**SKYLINE IMPROVEMENT AND SERVICE DISTRICT
MINUTES OF BOARD MEETING
October 21, 2021**

3. Q & A with Josh Kilpatrick, Nelson project engineer on WWDC Skyline Level II Study.

Comments on WWDC Study and Board Proposed Actions

Page 39-

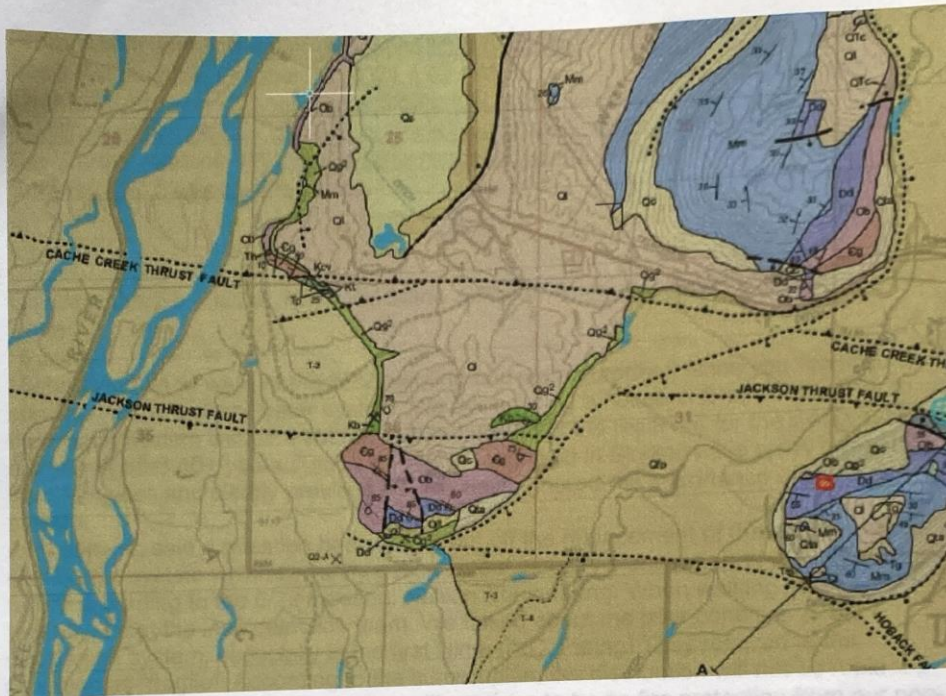
Second paragraph- you stated our Asbestos Concrete (AC) in the First Filing and PVC lines (the rest of Skyline) are nearing the end of their useful life. I think our PVC line (1974) is 47 years old and our AC (1965) is 56 years old. On table 11.10 (page 66), you give 20 years as assumed remaining useful life. Should we be expecting more repairs until lines are replaced given their increasing age? Yes, and it will be super important to track and record this information along with leakage and water audits. If we have a moderate earthquake are our AC or PVC lines at greater risk? I would say yes, but that truly depends on the intensity of a "moderate" earthquake. As parts of Skyline have bases of glacial loess, does loess provide a greater or less "cushion" in the event of a moderate earthquake. The ability of loess to provide earthquake protection is highly dependent on soil saturation. Loess is subject to liquefaction in a saturated condition; which condition is likely to occur in the Spring. In addition, per the image below, there are thrust faults that run through the subdivision, namely the Cache Creek and Jackson faults. Earth movement in the area would undoubtedly follow along the existing fault lines.

Figure 3.2: Skyline Ranch ISD Historical Water Well Water Production.

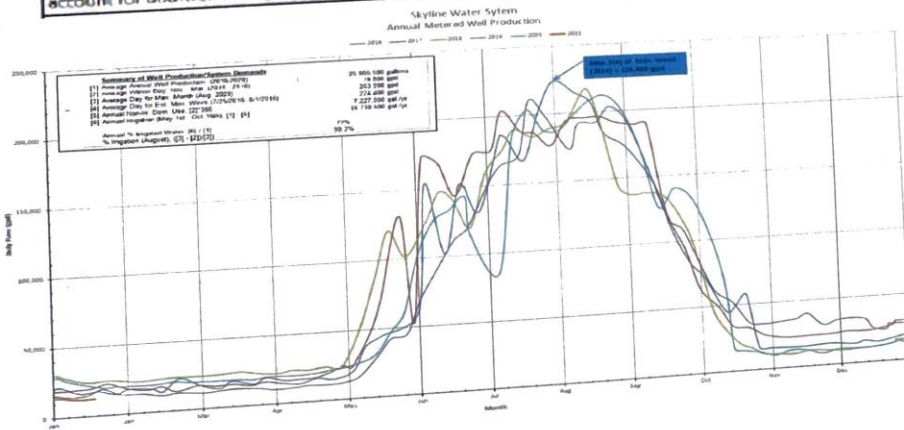
When do peak days and hours happen? How many days have peak hours?
